## IN THE UNITED STATES PATENT AND TRADEMARK OFFICE

Applicant:	Mark James Yunker	)	
Serial No.:	09/904,387	)	Group Art Unit: 3653
Filed:	07/12/2001	)	Examiner: Daniel K. Schlak
For: Slide	For Sorting Machine	)	
December 1	6, 2002		
	ner for Patents and Tradema , D.C. 20231	rks

### **RESPONSE TO OFFICE ACTION**

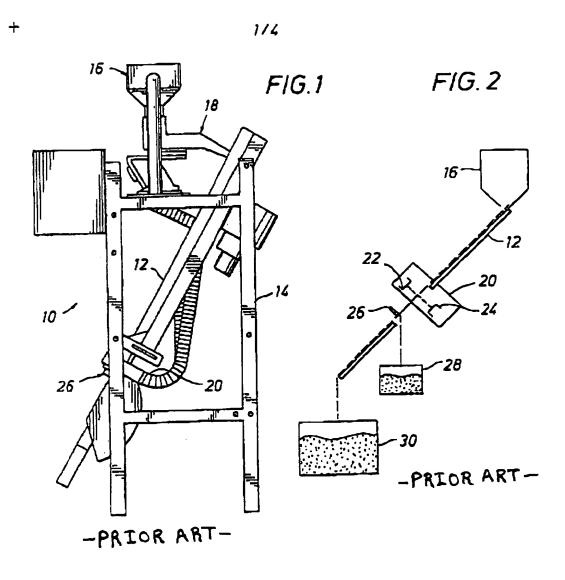
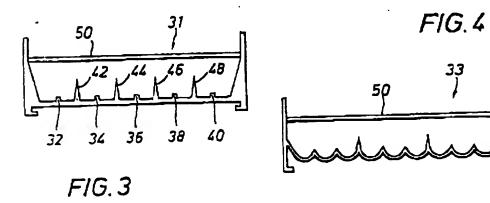
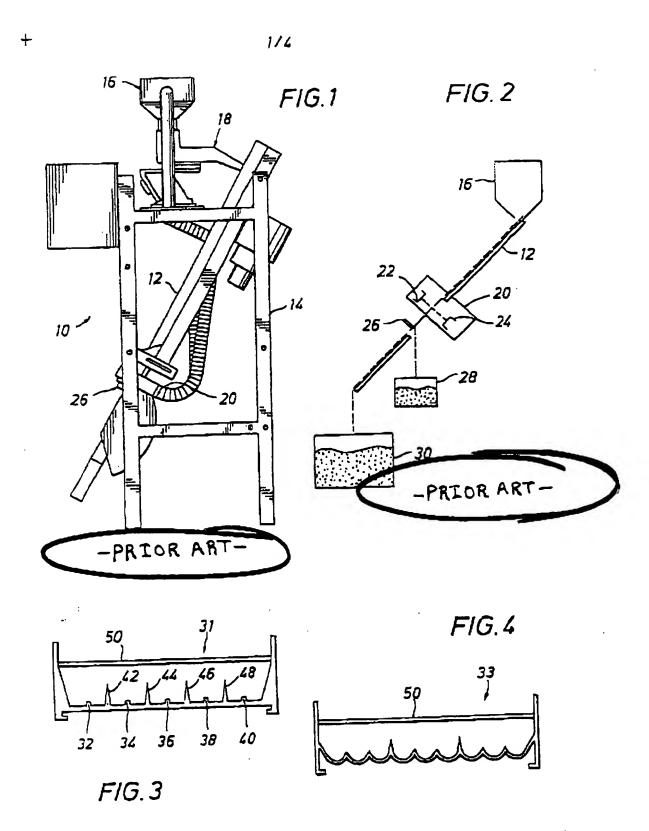
The applicant offers substitute drawings for Figs. 1 and 2 to include designations of --Prior Art--. Figs. 3 and 4 each depict a representative product guide 50. Product guide 50 is an aspect of the present invention, so marking of Figs. 3 and 4 as Prior Art has been deferred pending action on this response.
